ADDENDUM NO. 03

**Kalamazoo Public Schools Loy Norrix High School Mechanical Improvements
606 East Kilgore Road
Kalamazoo, MI 49001**

ADDENDUM NO. 3

PROJECT: Loy Norrix High School Mechanical Improvement D Wing
606 East Kilgore Road
Kalamazoo, MI 49001

SHEET NUMBER
TD 101D1
23-637.00
DATE
OCTOBER 31, 2025

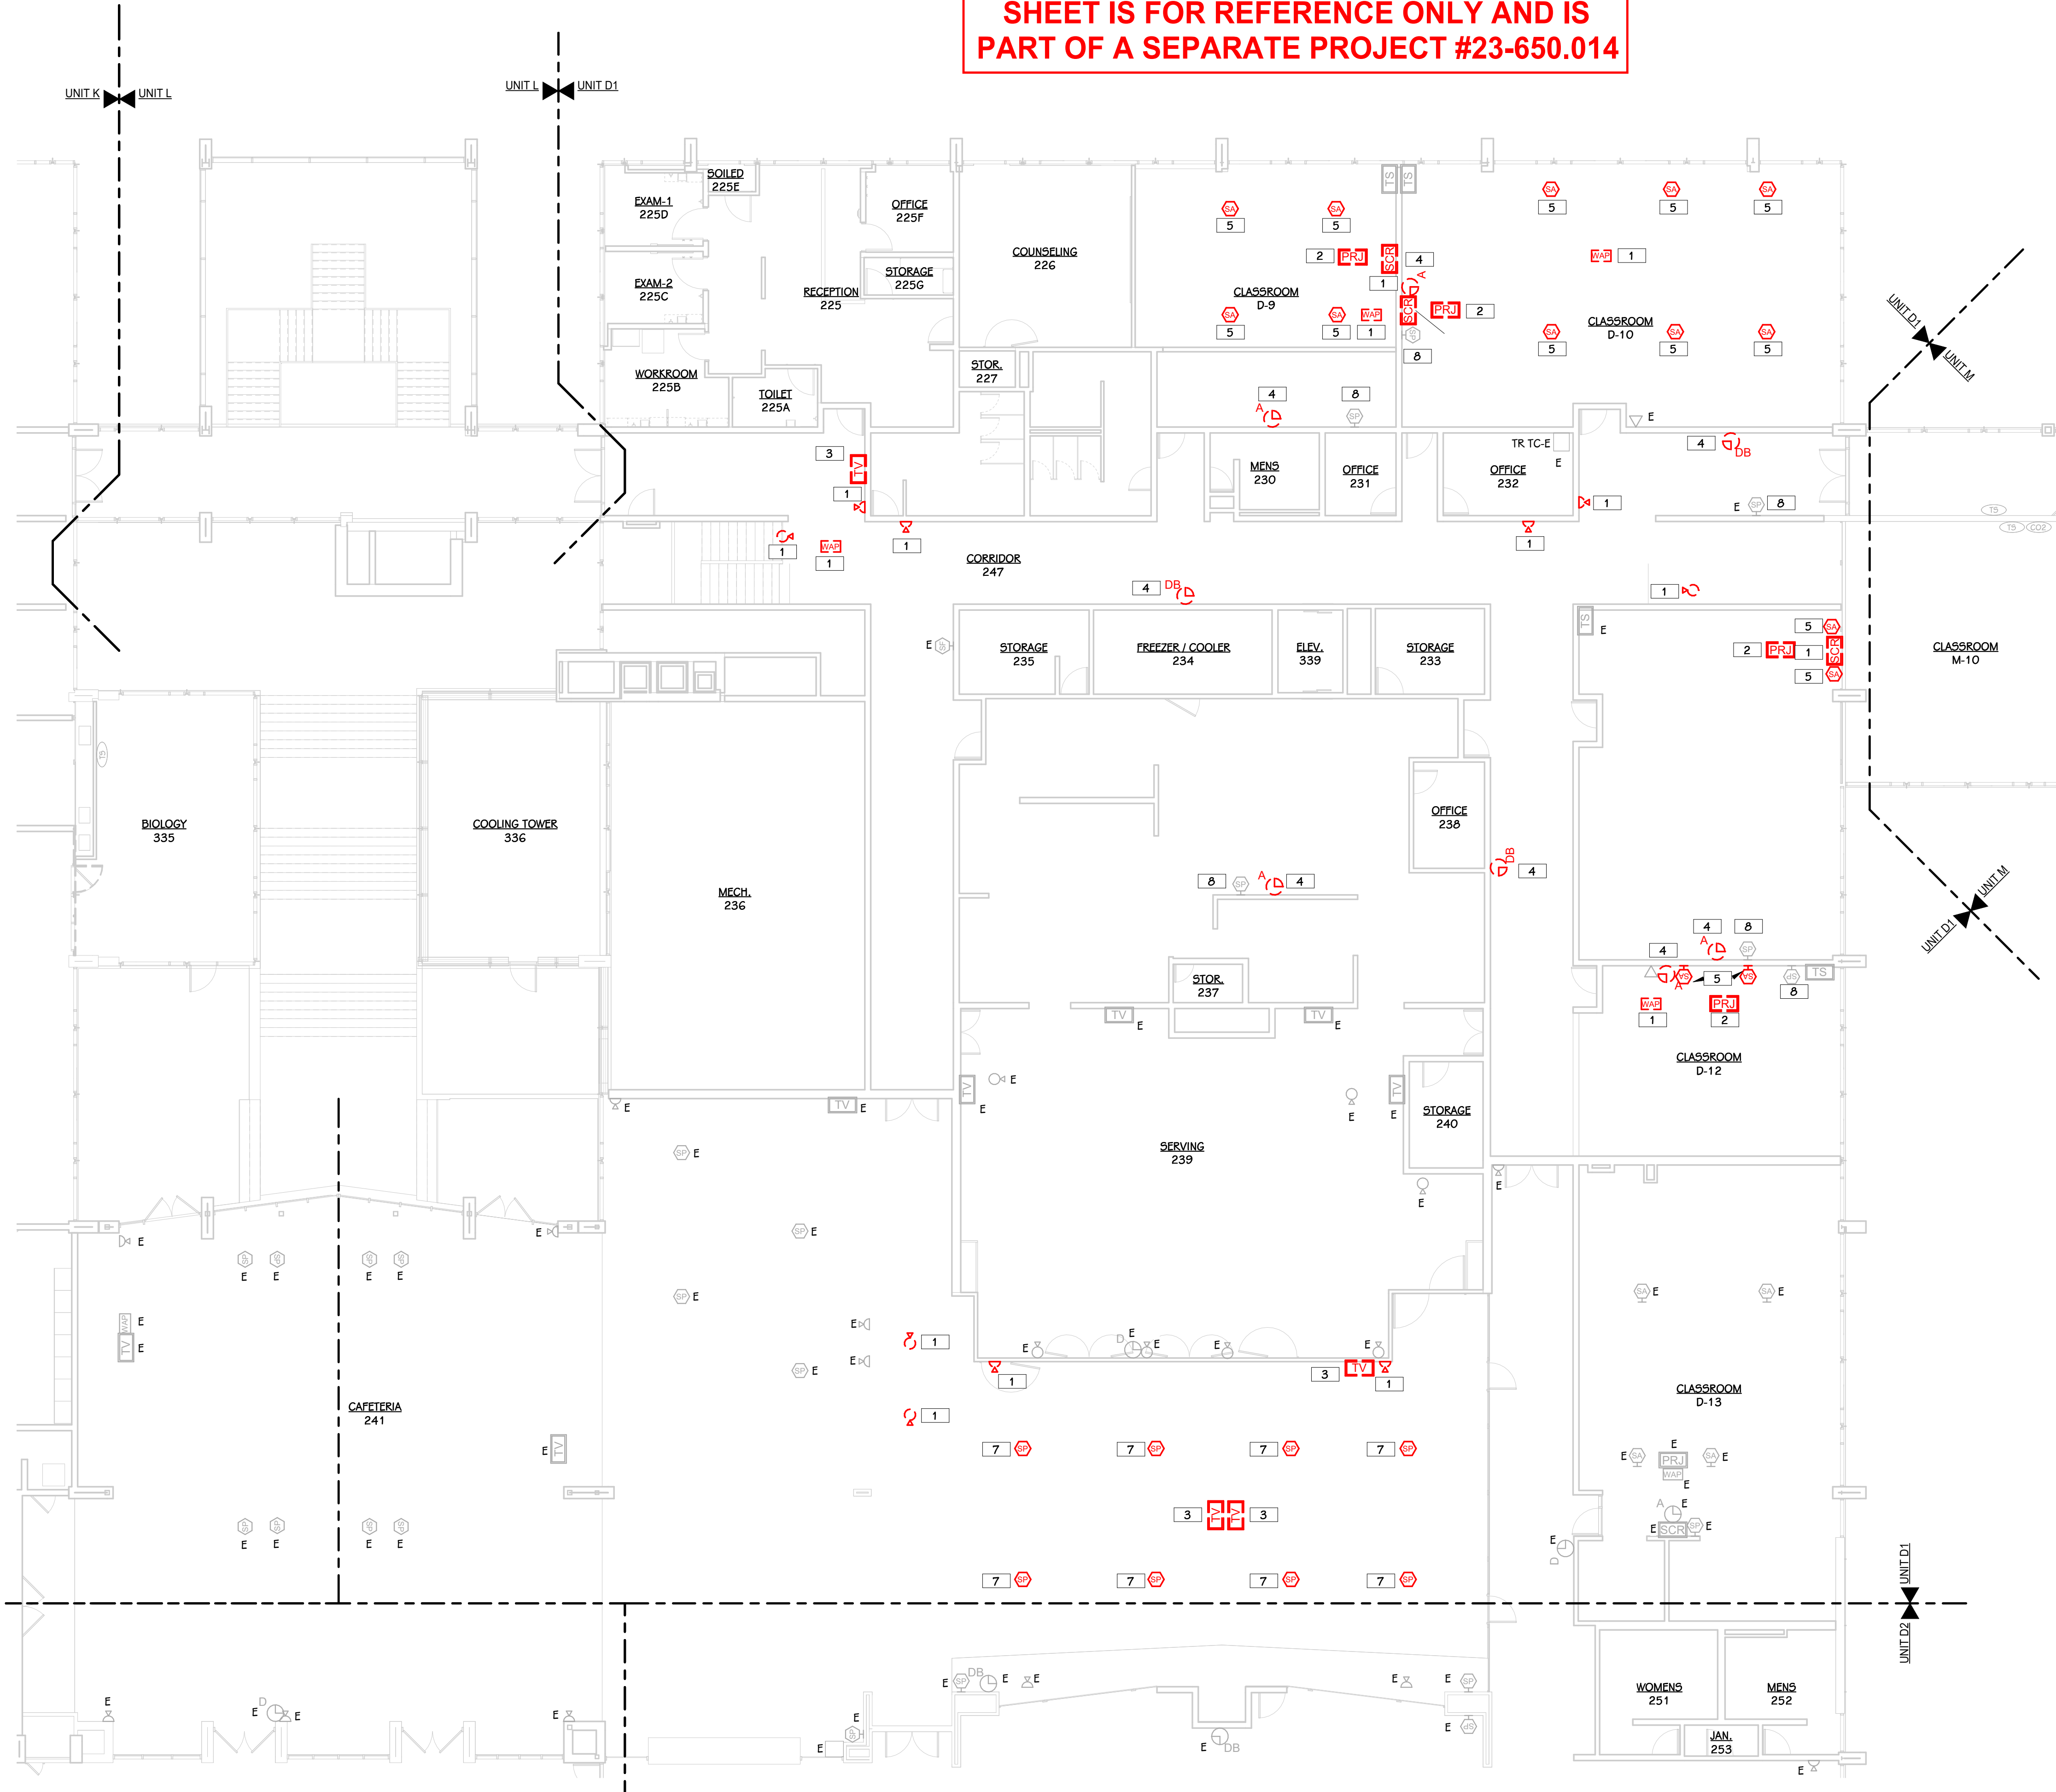
Refer to Sheet(s): TD 100D1, TD 101D1, TD 101D2, T 100D1, T 101D1, T 101D2

Updated the AV equipment storage location to Loy Norrix High School for the Technology Contractor. All technology "T" sheets are for reference only. Refer to updated keyed notes.

- 1 DEVICE SHALL BE REMOVED AND RETURNED TO LOY NORRIX HIGH SCHOOL STORAGE. COORDINATE STORAGE LOCATION WITH KPS FACILITIES. DOCUMENT CABLE ID, MAC ADDRESS, & DEVICE LOCATION. COIL CABLE AT CEILING FOR FUTURE INSTALLATION.
